GOVERNMENT OF THE DISTRICT OF COLUMBIA
DEPARTMENT OF TRANSPORTATION

MEMORANDUM

SUBJECT: **ZC Case No. 15-15** – Eckington Yards:
1611-1625 Eckington Place, NE and 1500 Harry Thomas Way, NE

Figure 1: Site Design and Access (Source: Grove/Slade Associates)

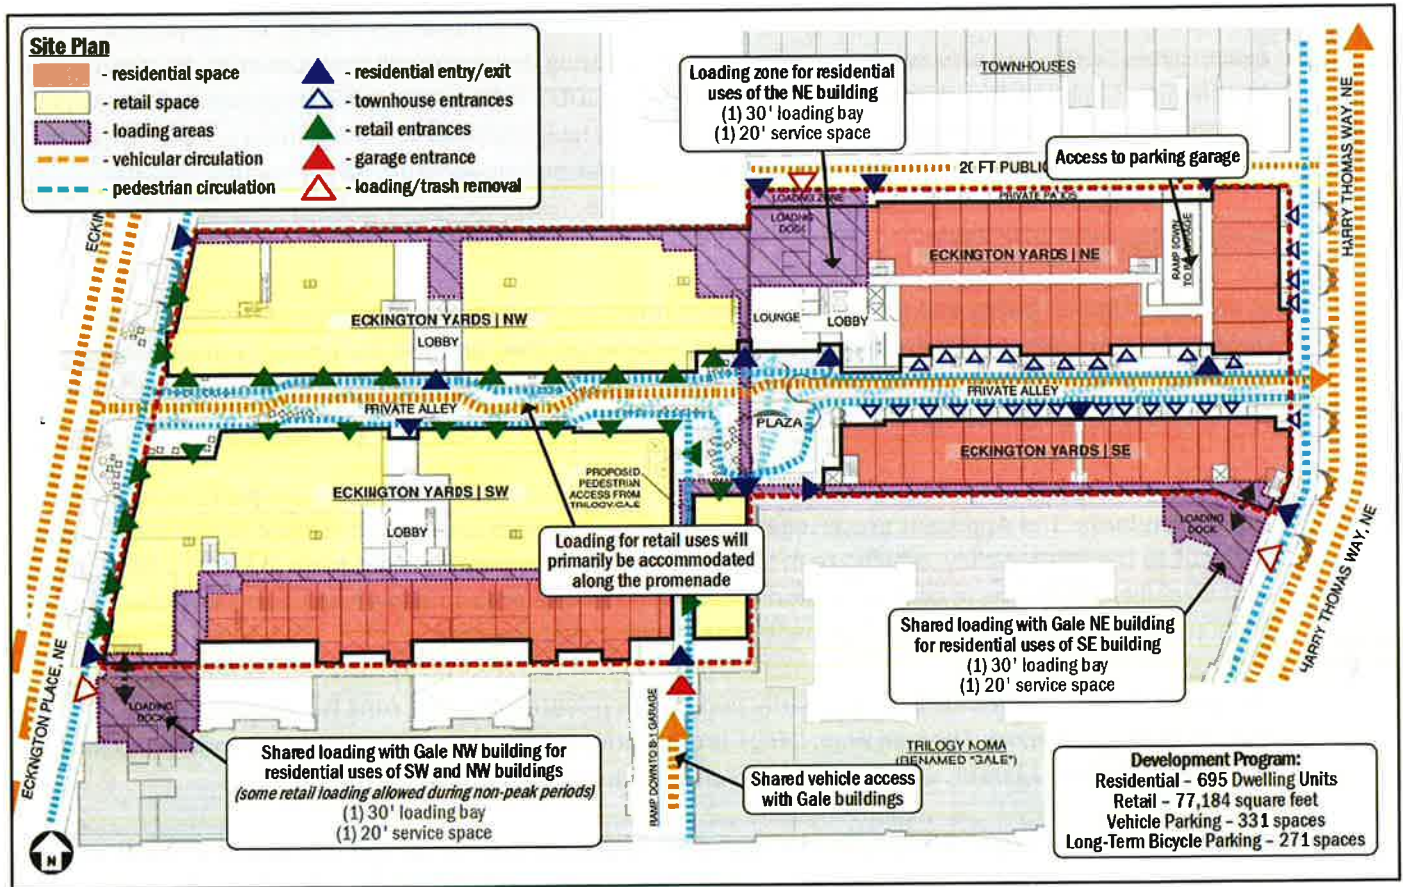
The proposed project is located adjacent to the existing Gale/NoMA Trilogy development (ZC 05-23) and proposes to share the loading facilities on Eckington Place and Harry Thomas Way with the existing development. These shared facilities do not meet DDOT standards due to backing movements in public space. While these curb cuts currently allow backing movements, the increased demand of the facilities and increased pedestrian, bicycle, and vehicular activity as a result of the increases potential conflicts. As such, the existing loading facilities must be redesigned to ensure front-in/front-out movements and a loading management plan is necessary to ensure safety, reduce conflicts, and ensure that demand of the existing loading facilities is not exceeded by the retail demand.

Additionally, two new curb cuts are proposed to lead to a primarily pedestrian private alley, which will be used for retail loading access. This alley will run west to east from Eckington Place to Harry Thomas Way. The design of the curb extensions on Eckington Place at this new private alley may need to be altered to allow truck turns into the alley, as truck turning movements currently show trucks tracking over the curb. The loading management plan, described above, will be required by DDOT as a condition of support for these two curb cuts. Finally, an existing public alley on Harry Thomas Way will be used for loading and vehicular access. This access is appropriate.

DDOT does not support backing movements for loading onto Eckington Place and Harry Thomas Way. While this is an existing condition for the Gale/NoMA development, the increased use of the loading

DDOT expects the Applicant to design and build the streetscape surrounding the property to current DDOT standards. The Applicant proposes to build curb extensions on Eckington Place at the proposed curb cut to the private alley, which are in line with the recommendations set forth in DDOT's Mid-City East Livability Study. These curb extensions may need to be altered to allow truck turns into the alley, as truck turning movements currently show trucks tracking over the curb.

DDOT does not support backing movements for loading onto Eckington Place and Harry Thomas Way. While this is an existing condition for the Gale/NoMA development, the increased use of the loading facilities on roadways that have increased pedestrian, bicycle, and vehicular traffic volumes as a result of this project exacerbates DDOT concerns regarding safety. DDOT expects the Applicant to revise their plans to provide head-in/head-out movements for all loading facilities, in keeping with DDOT standards.

Figure 5: DDOT's Mid-City East Livability Study Improvements (Source: Grove/Slade Associates)

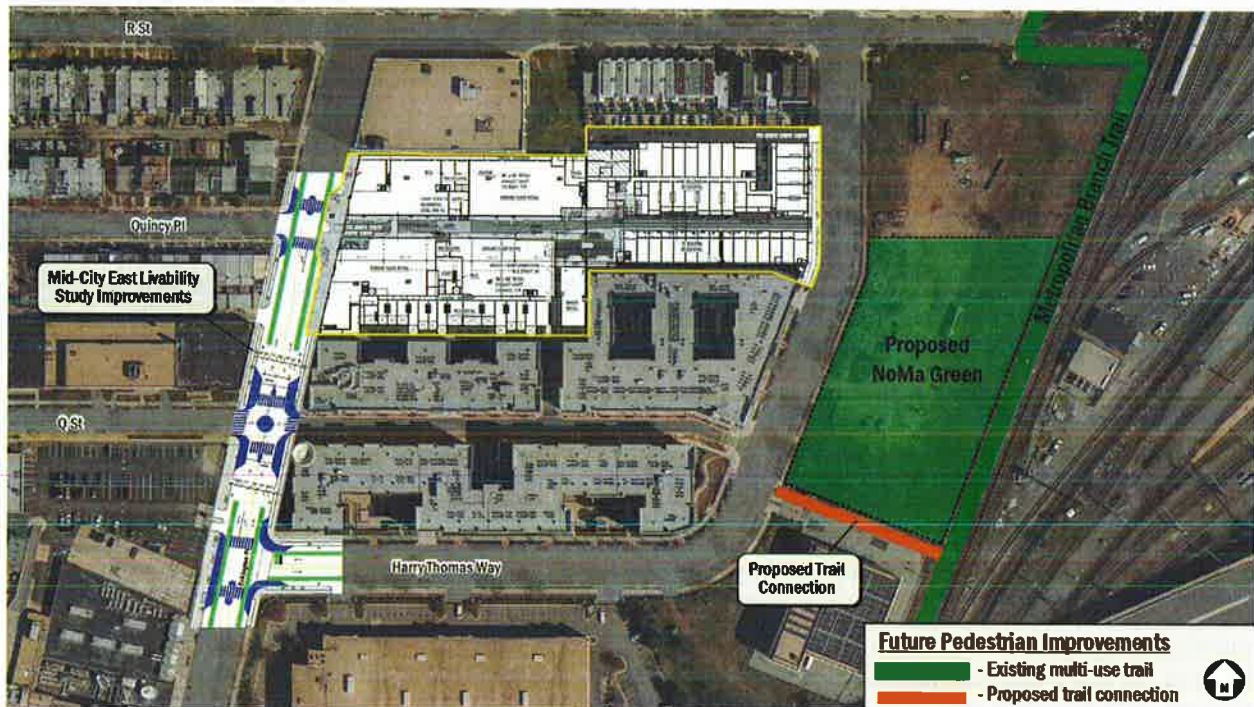
For Eckington Place/Florida Avenue, NE, the site generated trips degrade the operation of the southbound approach from LOS D to LOS E during the morning and afternoon peak hours. No mitigations are proposed by the Applicant. Increased TDM measures and the design and construction of the traffic calming and pedestrian recommendations of DDOT's Mid-City East Livability Study Improvements at Eckington Place/Quincy Place, NE, Eckington Place/Q Street, NE, and Eckington Place/Harry Thomas Way, NE (see Figure 5) will support increased pedestrian activity and support their proposed non-auto mode split.

The Applicant performed an inventory of the pedestrian infrastructure surrounding the site. The Applicant proposes to improve the pedestrian infrastructure and streetscape in front of their site, along Eckington Place and Harry Thomas Way. The site generates a high number of pedestrian trips – 71 AM peak and 167 PM peak trips, which does not account for the pedestrians walking to access nearby transit (an additional 248 AM peak and 430 PM peak trips). To support this mode split, in addition to mitigating impacts to the vehicular network, DDOT finds that the implementation of DDOT's Mid-City East Livability Study Improvements at Eckington Place/Quincy Place, NE, Eckington Place/Q Street, NE, and Eckington Place/Harry Thomas Way, NE (see Figure 5) by the Applicant is necessary.

- Design and construct traffic calming and pedestrian recommendations of DDOT’s Mid-City East Livability Study Improvements at Eckington Place/Quincy Place, NE, Eckington Place/Q Street, NE, and Eckington Place/Harry Thomas Way, NE;

The Applicant does not provide any recommendations for mitigation of site impacts at the intersection of Eckington Place and Florida Avenue due to the on-going study of the Virtual Circle by DDOT. However, the site-generated trips degrade the operation of the southbound approach from LOS D to LOS E during the morning and afternoon peak hours. Design and construction of the traffic calming and pedestrian recommendations of DDOT's Mid-City East Livability Study Improvements at Eckington Place/Quincy Place, NE, Eckington Place/Q Street, NE, and Eckington Place/Harry Thomas Way, NE (see Figure 5) will support increased pedestrian activity and support the Applicant's proposed non-auto mode split.
